Overview

The purpose of this notification is to communicate a circuit revision change to the CoolRunner™ XPLA3™ family of CPLD devices.

Design Circuit
Revision Code

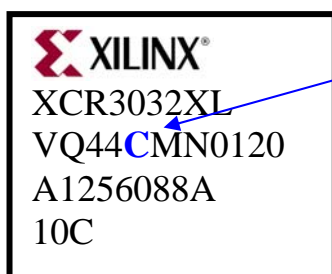
The design circuit revision code on the package topmark can be found as shown below.
